SERVICE BULLETIN

M-1238

2009 DYNA JIFFY STAND SPRING ANCHOR SAFETY RECALL 0137

Figure 1. Jiffy Stand Assembly

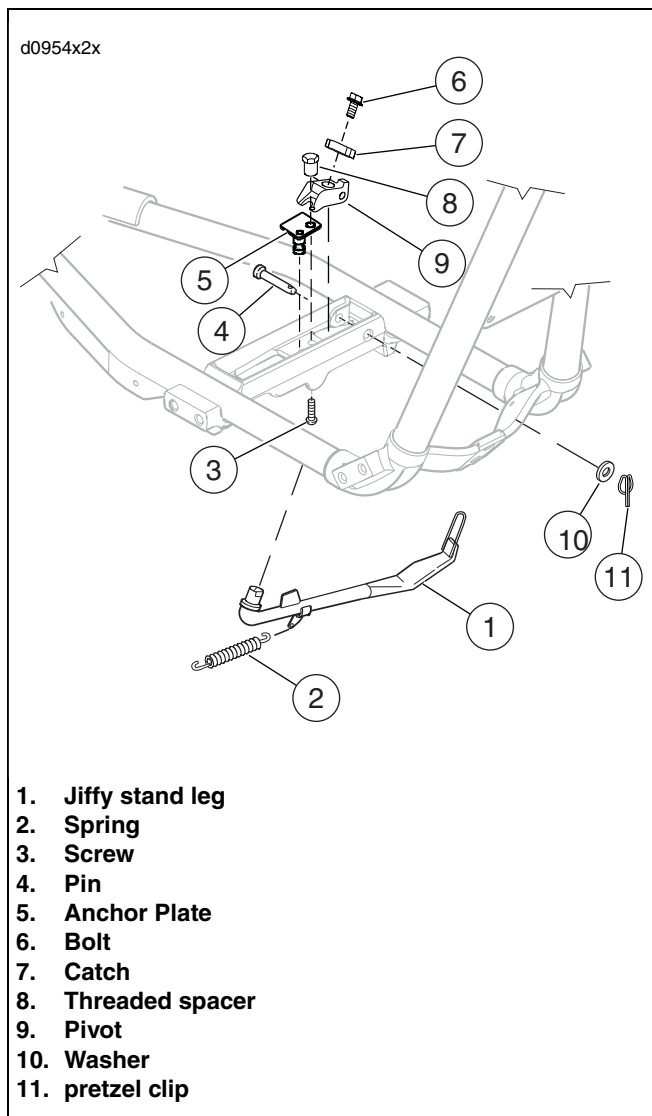
Harley-Davidson has determined that a condition affecting motor vehicle safety exists on certain 2009 model year Dyna FXD, FXDF, FXDC, FXDL, FXDB vehicles. These motorcycles have a jiffy stand Spring Anchor Part No. 47318-98, that may have been made with a defective weld that may allow the jiffy stand assembly to not retract as intended. This condition could lead to an accident which could cause injury or death to the rider.

See Figure 1. Do not disassemble jiffy stand assembly once removed from chassis.

3. Remove the anchor plate (5) from frame.
4. Install **new** anchor plate from the recall kit.
5. Install jiffy stand assembly using **new** screw (3) provided in kit. See Chapter 2 of the 2009 DYNA Models Service Manual.
